V2500-A1 SERIES NACELLE SERVICE BULLETIN

V2500-NAC-26-0002

NACELLE – POWERPLANT – FIRE PROTECTION – OVERHEAT DETECTOR – REPLACEMENT OF1. Planning InformationA. Effectivity

TITLE: MODIFICATION OF NACELLE TEMPERATURE SENSOR

Installation of the Overheat Detector
Figure 1

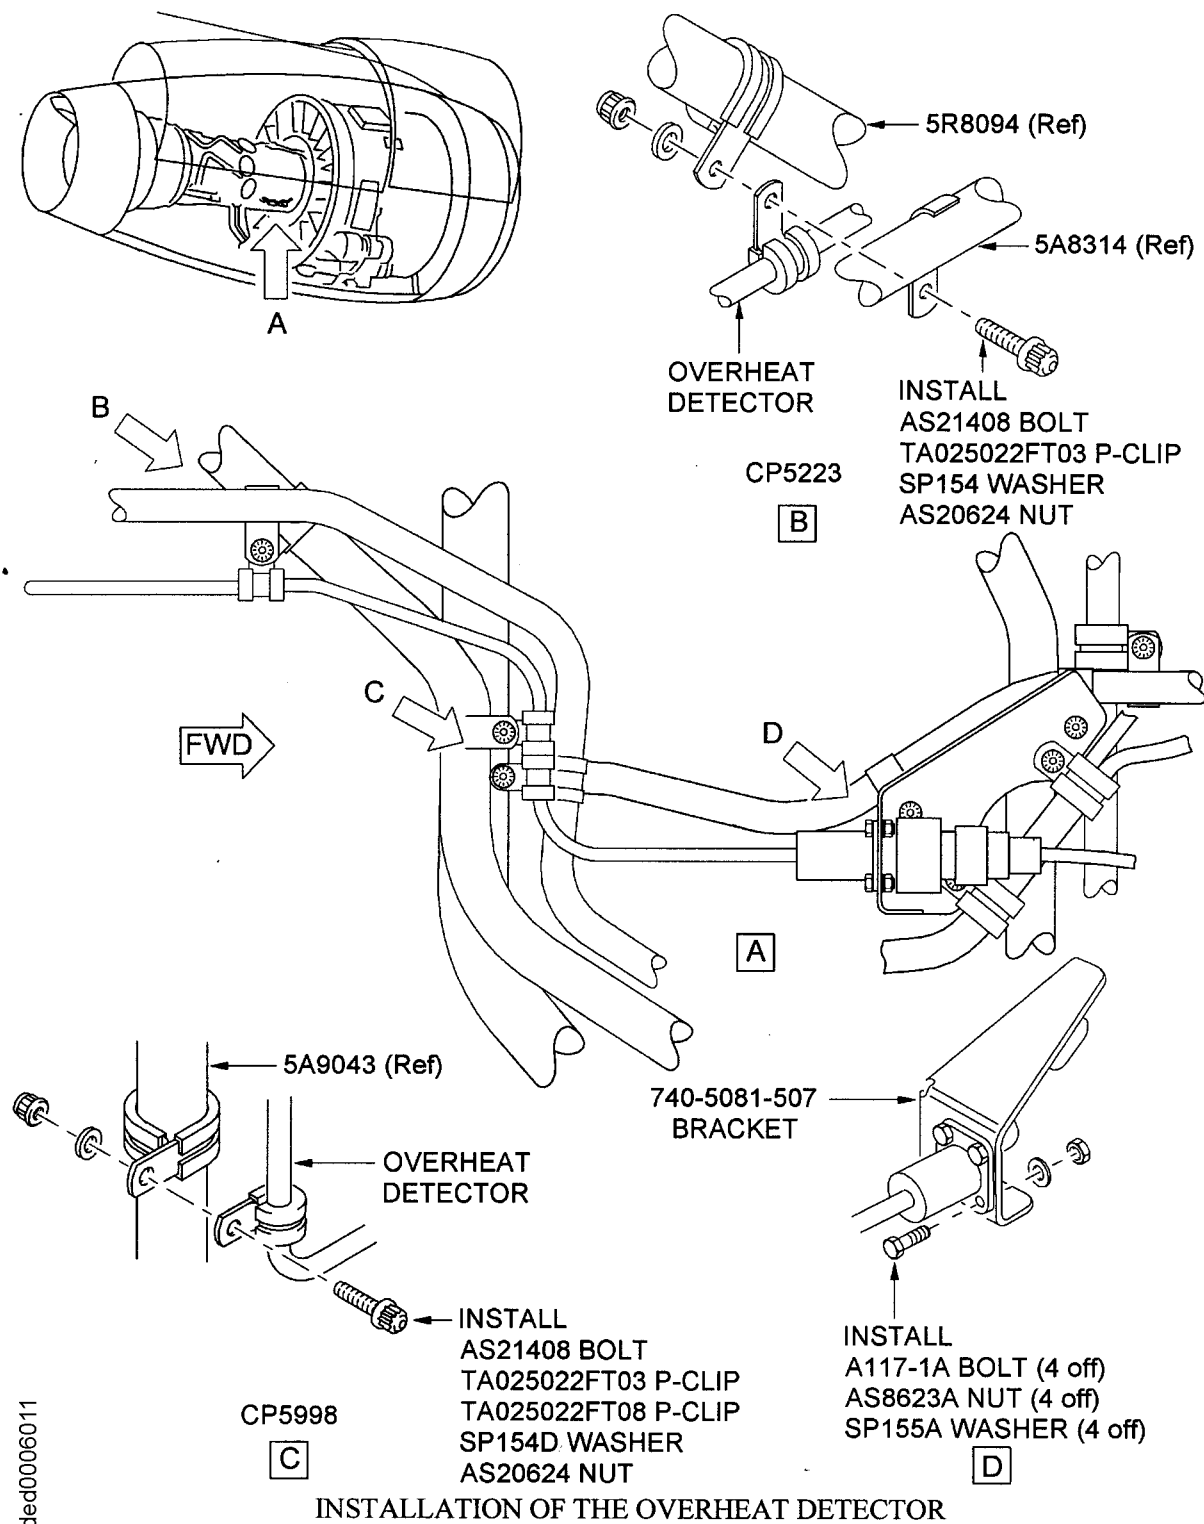
(a) Clipping point CP5998 replaces clipping point CP5221 to accommodate the new Overheat Detector. The remaining clipping point (CP5223) is unaffected. Refer to Figure 1.

- (1) Install the RP162-02 Overheat Detector to the 740-5081-507 Bracket with the four A117-1A Bolts, four AS8623A Nuts, and four SP155-A Washers. Hand tighten the Nuts. Refer to Figure 1.
- (2) Safety the Overheat Detector to the 5A9043 Tube (clipping point CP5998) with the TA025022FT03 Clamp, TA025022FT08 Clamp, AS21408 Bolt, SP154D Washer, and AS20624 Nut. Hand tighten the Nuts.
- (3) Safety the Overheat Detector at clipping point CP5223 as shown, with the TA025022FT03 Clamp, AS21408 Bolt, SP154D Washer, and AS20624 Nut. Hand tighten the Nut.
- (4) Make sure there is a minimum clearance of 0.25in (6,3 mm.) between the Overheat Detector and adjacent structure/tubes.
- (5) Torque the Nuts in step (1) to 20 to 25 lbf in (2 to 3 Nm).
- (6) Torque the Nuts in steps (2) and (3) to 40 lbf in (4,5 Nm).

Figure 1

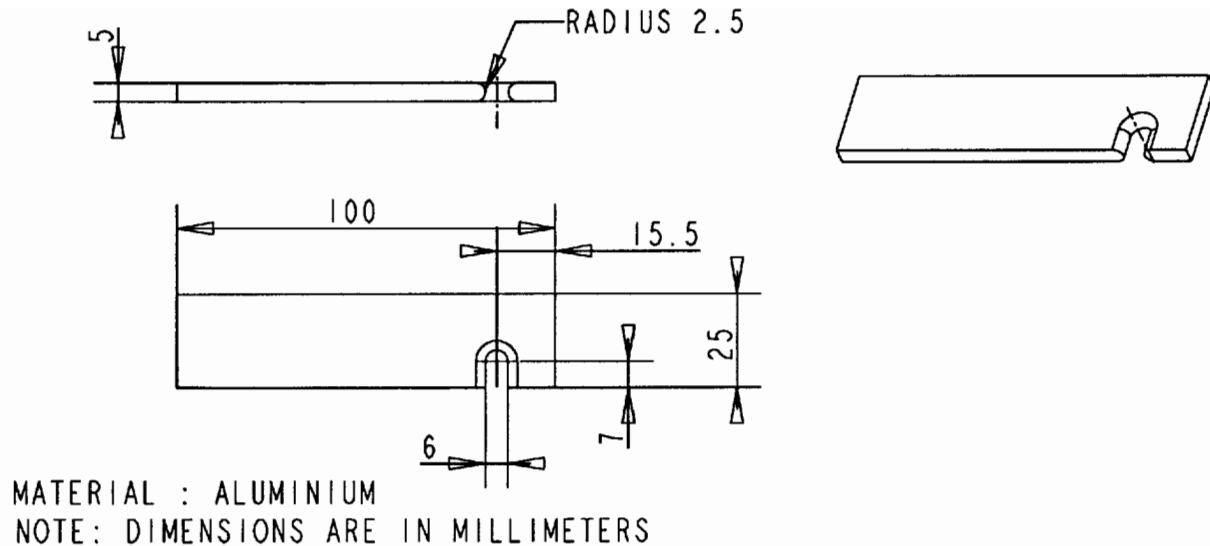
Local manufacture two parts as defined in figure 1.

1. Manufacture two shaping tools from 5 mm thick aluminium plate (or similar material), to the dimensions given in figure 1. Remove any burrs or sharp edges from the tools.

Figure 2

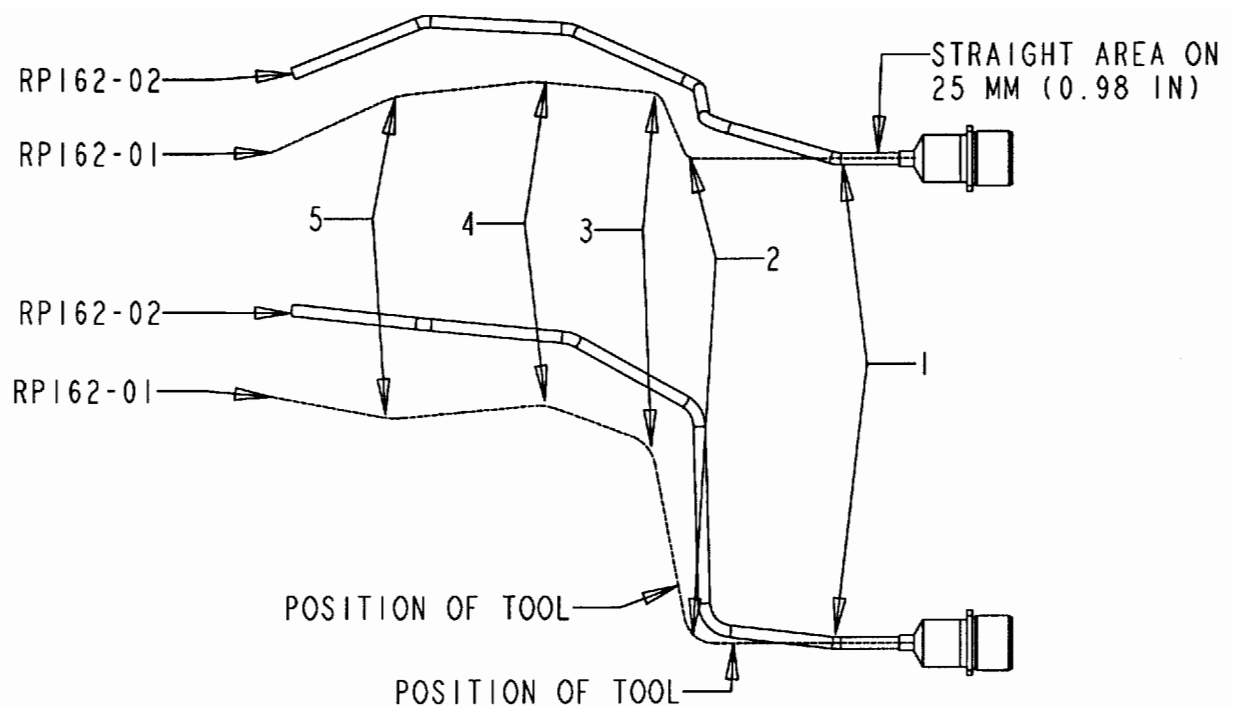
CAUTION: NEVER BENT THE RIGID METAL SHEATH IN THE STRAIGHT AREA 25 MM (0.98 IN). SEE FIGURE 2.

1. Insert the two shaping tools on both sides of each bending radius to the different areas to be modified (Note positions of tools for area 2 on figure 2) curve lightly the rigid metal sheath and obtain dimensions defined figure 3.
2. Proceed step by step from area 1 to 5.

Figure 3
RP162-02 Dimensions to be obtained

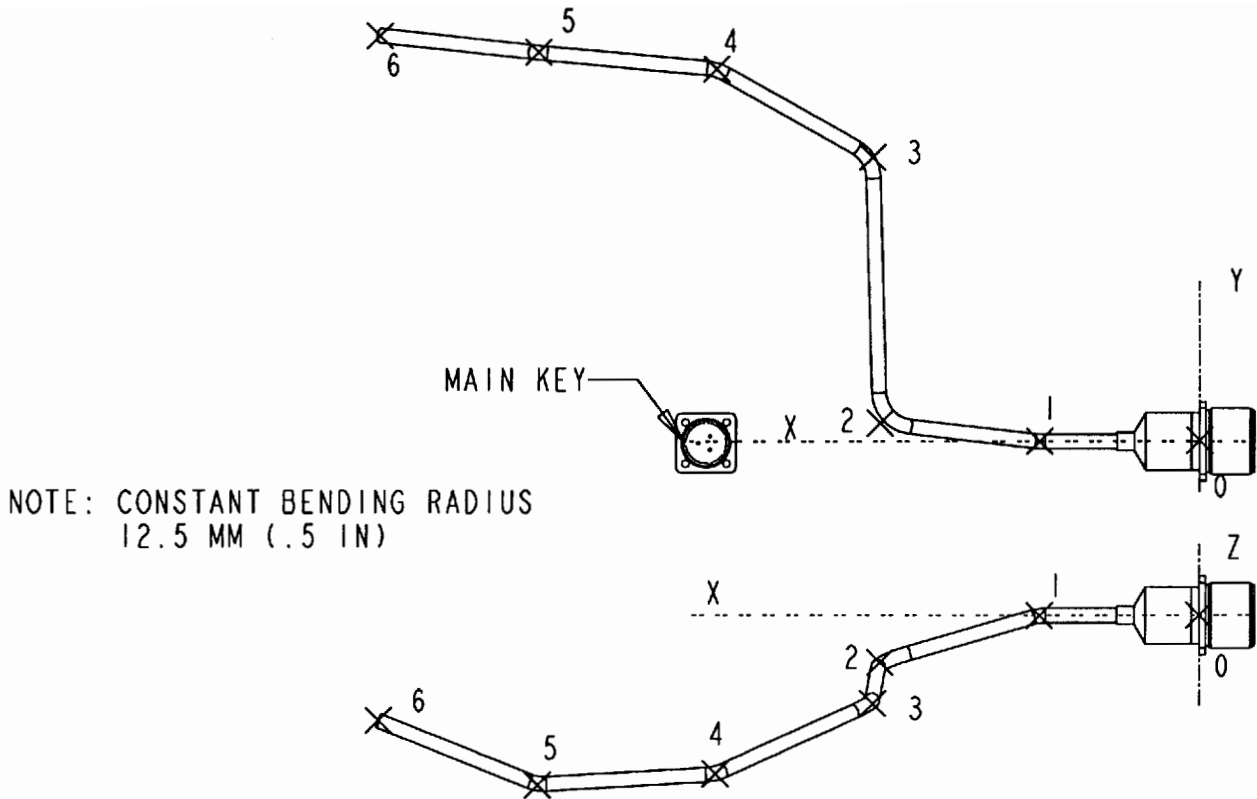
To provide instructions to modify the shape of the rigid metal tube. The new configuration will become P/N : RP162-02.

MM	X	INCH	MM	Y	INCH	MM	Z	INCH
0	0.0		0.0	0.0	0.0		0.0		0.0
1	52.50		2.07	0.0	0.0		0.0		0.0
2	105.26		4.14	6.05	0.24		-15.4		-0.61
3	107.69		4.24	94.66	3.73		-29.34		-1.15
4	159.38		6.27	123.79	4.87		-52.90		-2.08
5	218.05		8.58	129.34	5.09		-56.20		-2.21
6	270.57		10.65	135.07	5.32		-34.97		-1.38
